UNITED STATES PATENT AND TRADEMARK OFFICE

APPLICATION NO.	FILING DATE	FIRST NAMED INVENTOR	ATTORNEY DOCKET NO.	CONFIRMATION NO.
10/773,631	02/06/2004	Alexander Star	612407-23	8346
23879	7590	11/01/2006		
BRIAN M BERLINER, ESQ O'MELVENY & MYERS, LLP 400 SOUTH HOPE STREET LOS ANGELES, CA 90071-2899			EXAMINER SINES, BRIAN J	
			ART UNIT	PAPER NUMBER
			1743

Office Action Summary

DETAILED ACTION***Drawings***

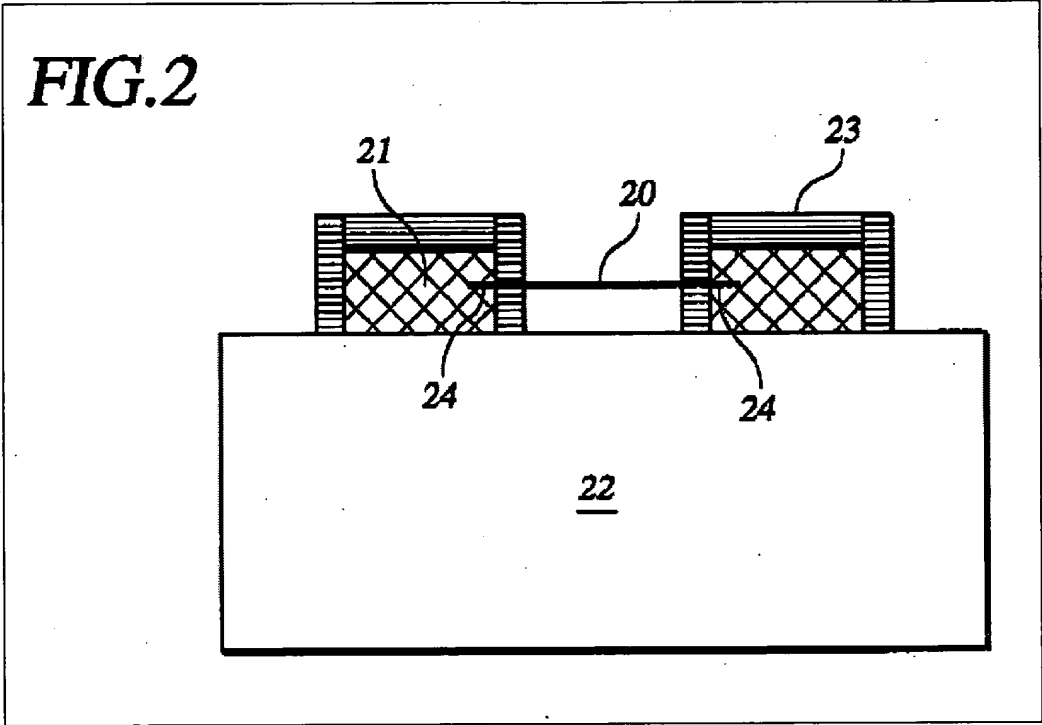
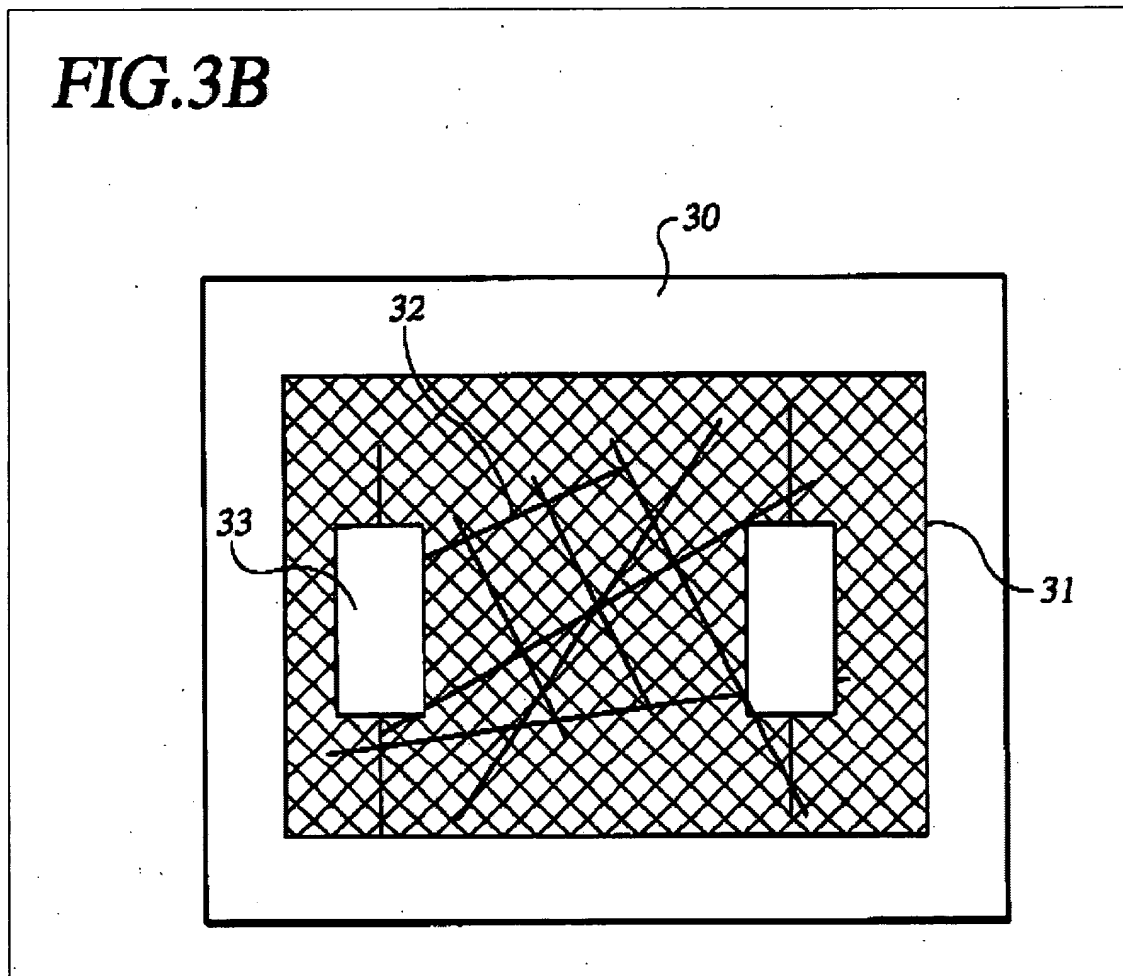
Regarding claims 1 and 2, Dai teaches an apparatus comprising: a substrate 22, 30; at least one nanotube 20, 32 disposed on the substrate; at least one electrical contact 23, 33, wherein the contact is in electrical communication with the at least one nanotube (see figures 2 and 3B; col. 4, lines 23 – 65).

Regarding claim 3, as shown in figures 2 and 3B, the nanotube 20, 32 spans the distance between two electrical contacts 23, 33.

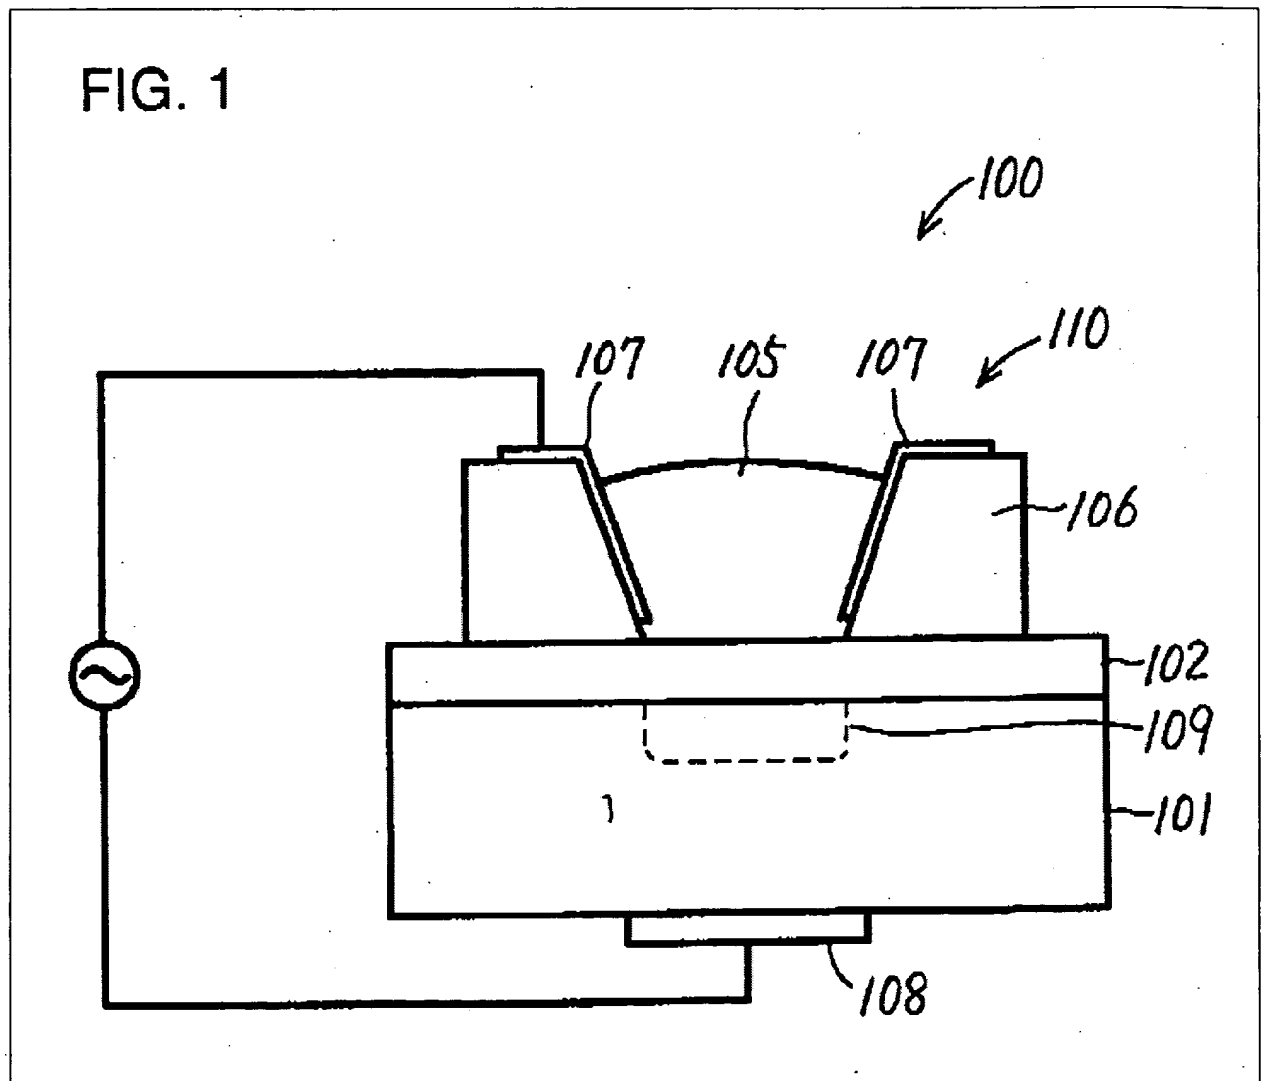
Dai does not specifically teach the incorporation of a sample exposure portion to maintain a liquid analyte sample in contact with at least one nanotube. However, the use of containing means for holding a sample for analysis with sensing devices is considered well known in the art (see MPEP §2144.03). For example, Akioka teaches a sensing device comprising a sample exposure portion (e.g., storage part 110) with electrical contact 107 for sensing the solution 105 (see, e.g., col. 2, lines 15 – 28; figure 1).

Hence, as indicated by Akioka, a person of ordinary skill in the art would accordingly have had a reasonable expectation for success of incorporating such a sample exposure means with a sensing device for analyzing a sample solution (see MPEP § 2143.02). Therefore, it would have been obvious to a person of ordinary skill in the art to incorporate a sample exposure portion as claimed with the disclosed sensing device to facilitate effective liquid analyte sample contact with the nanotube for sensing.
